BCA ASSESSMENT REPORT

Memorial Avenue

Prepared for:

Ref.: 180284

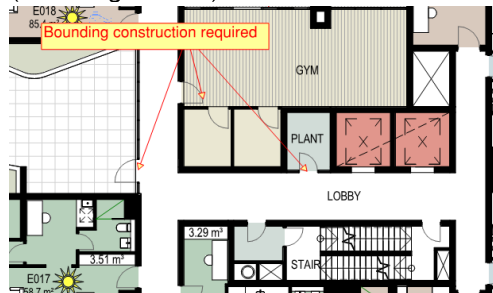
C2.8 Separation of classifications in the same storey	<p>Different building classifications situated adjacent to each other in the same storey are required to adopt the higher FRL prescribed in Specification C1.1 or have the parts of the building separated by a fire wall.</p>	<p>Compliance is Readily Achievable:</p> <p>The Level 1 Restaurant area is to be separated from the remainder of the building by a fire wall and therefore fire rated elements are required to achieve the most stringent requirement of the included classifications as prescribed in Specification C1.1.</p> <p>In this instance the FRLs of the restaurant bounding walls are to achieve 180/180/180</p> <p><u>Note:</u> The restaurant space exceeds 10% of the floor area of level 1.</p>
C2.9 Separation of classifications in different storeys	<p>This clause specifies the required separation between parts of a building which are of a different classification, situated one above another, to minimise the risk of a fire in one classification causing the failure of building elements in another classification in a different storey.</p>	<p>Further Information Required:</p> <p>The floors between different classifications need to be fire rated in accordance with Specification C1.1 as follows:</p> <ul style="list-style-type: none"> + Floors above the Class 2 parts require an FRL of 90/90/90, + Floors above the Class 7a parts (FRL of 120/120/120); + Floors above the Class 6 part (FRL of 180/180/180)

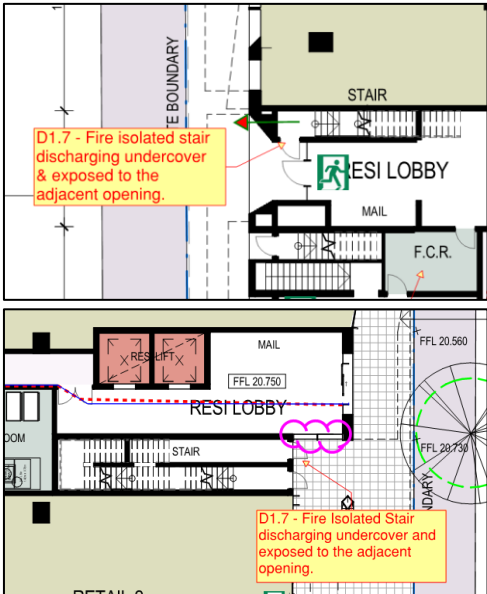
C3.17 Columns protected with lightweight construction to achieve an FRL	A column protected by lightweight construction to achieve an FRL which passes through a building element that is required to have an FRL or a resistance to the incipient spread of fire, must be installed using a method and materials identical with a prototype assembly of the construction which has achieved the required FRL or resistance to the incipient spread of fire.	Compliance Readily Achievable: Details to be included into the design.
Spec.	Specifications	
Spec C1.1 Fire resisting construction	The new building works are required to comply with the requirements detailed under Table 3 of Specification C1.1 for Type A Construction.	Further Information Required: Compartment plans are to detail the FRLs that will be provided throughout based on the requirements of Table 3 of Specification C1.1 (refer to appendix 3). Performance Solutions are worth pursuing for the following area: <ul style="list-style-type: none"> Garbage chutes – allow the garbage room to retain the fire rating of the base rather than fire rating of the shaft.

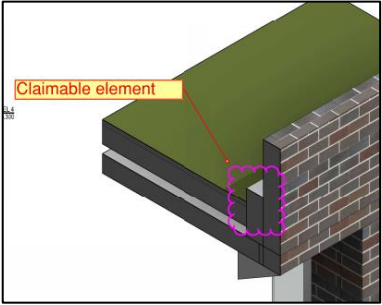
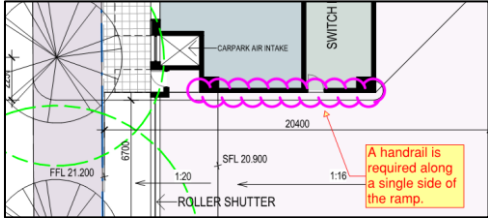
D1.17 Access to lifts pits	<p>This clause provides the requirements for access to lift pits not more than 3m deep and the requirements of construction of access for lift pits that are more than 3m deep. The requirements for signage to lift pits are also set out.</p>	<p>Compliance Readily Achievable:</p> <p>Details to be included into the design.</p>
